FOR
DR. TOBY AND CHRIS HANAHAN
BEING A PART OF LOT NO. 41, IN THE TOWNSHIP OF PERRY, COUNTY OF LAKE, STATE OF OHIO
SCALE: 1"=30'
N
EXIST PROP
CURTAIN DRAIN DETAIL
24" MIN
SOIL (2" MIN)
STRAW
4" RIGID PERF PIPE
3/4" GRAVEL
LEACH FIELD
F.E. & C.V. GIBAS
VOL 833-455
L.C. NURSERY EXCHANGE
VOL 777-1272
S 87°31'55"E 436.82'
S 87°33'29"E 2021.06'
WATER CONN
GRAVEL D/W
N 87°30'04"W 465.60'
CHRISTINE HANAHAN
VOL 678-763

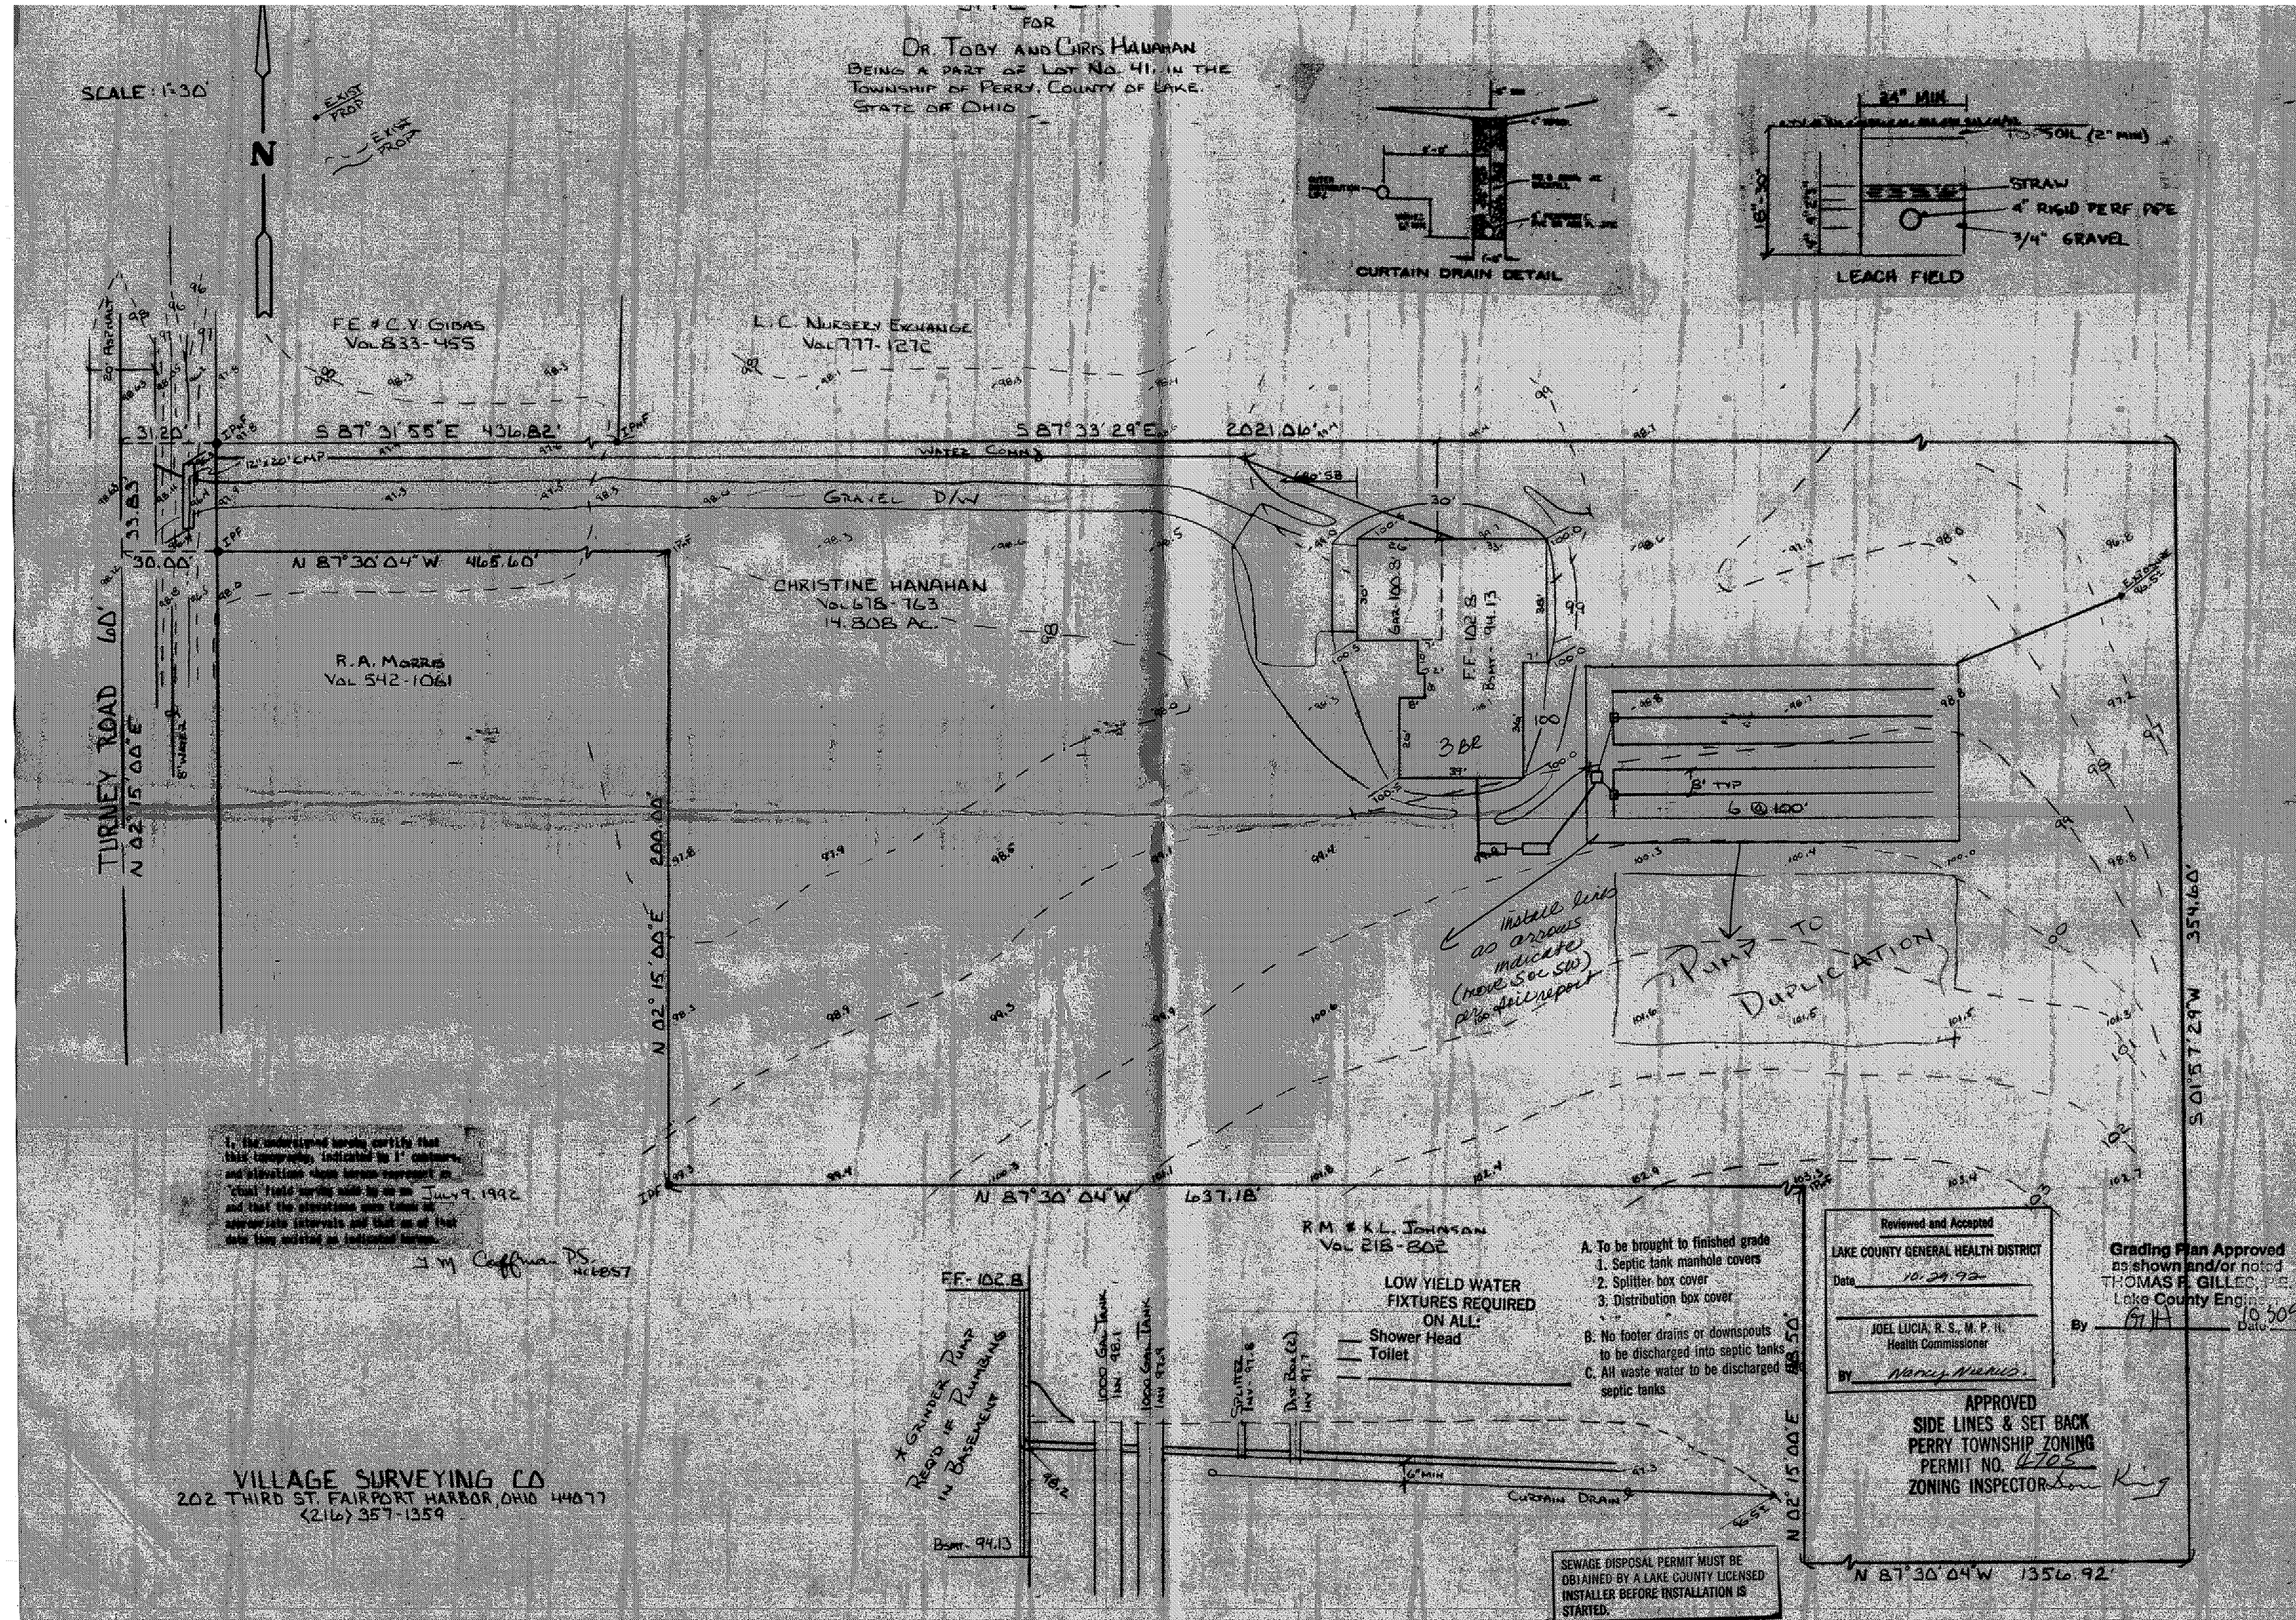
14.808 AC.
R.A. MORRIS
VOL 542-1061
TURNEY ROAD 60'
N 02°15'00"E
N 02°15'00"E 200.00'
S 01°57'29"W 354.60'
N 87°30'04"W 637.18'
N 87°30'04"W 1356.92'
N 02°15'00"E 88.50'
3 BR
6 @ 100'
PUMP TO DUPLICATION
install lines as arrows indicate (move 50' SW) per soil report
R.M. & K.L. JOHNSON
VOL 218-802
FF-102.8
GRINDER PUMP REQ'D IF PLUMBING IN BASEMENT
1000 GAL TANK INV 98.1
1000 GAL TANK INV 97.9
SPLITTER INV 97.8
DIST BOX (2) INV 97.7
CURTAIN DRAIN
6" MIN
BSMT 94.13
LOW YIELD WATER FIXTURES REQUIRED ON ALL:
Shower Head
Toilet
